Office Action Summary

10/627,069

FERMANN ET AL.

DETAILED ACTION

FIG.2

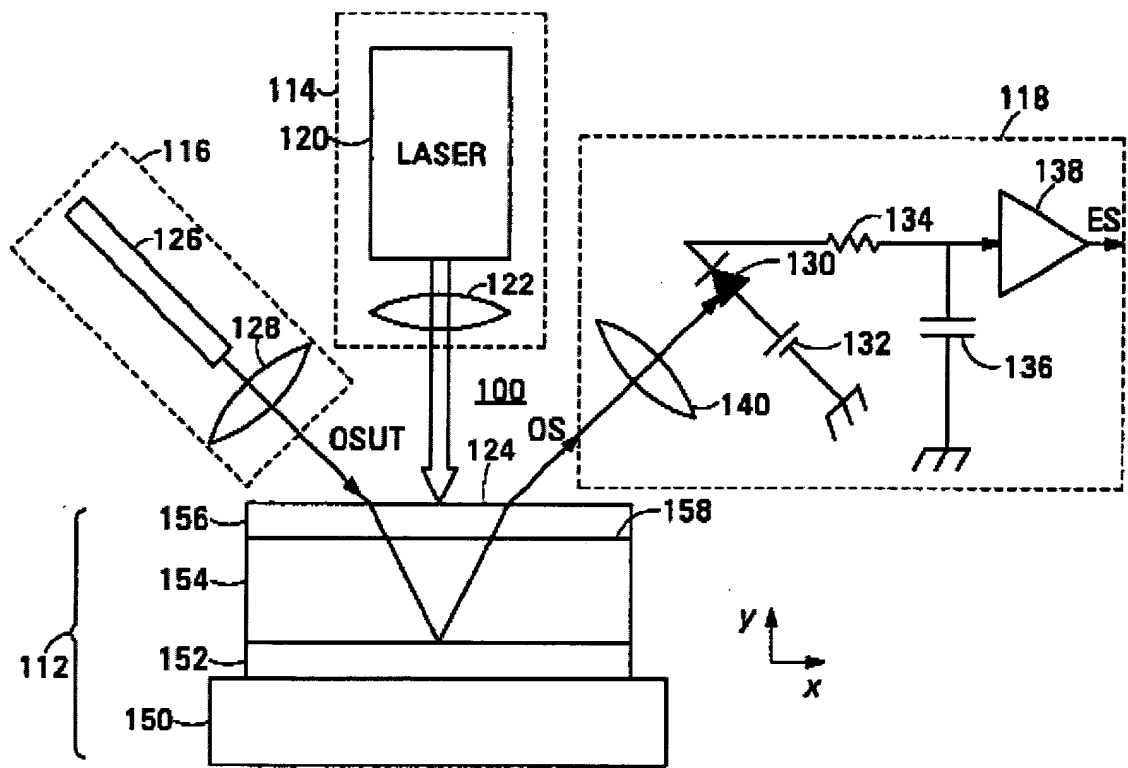
Regarding claim 35, Kaneko discloses a saturable absorber mirror for passive modelocking of lasers, comprising: a film (see Fig. 2 Character 154) of a semiconductor material implanted with high energy ions at a penetration depth which differs from the penetration depth of optical signals reflected from said saturable absorber mirror (Fig. 2, Paragraphs 11 and 13) .

Regarding claim 48, Kaneko disclose a film of a semiconductor material implanted with high-energy ions at a penetration depth which is smaller than the penetration depth of optical signals reflected from said saturable absorber mirror (Fig. 2, Paragraphs 2 and 13).
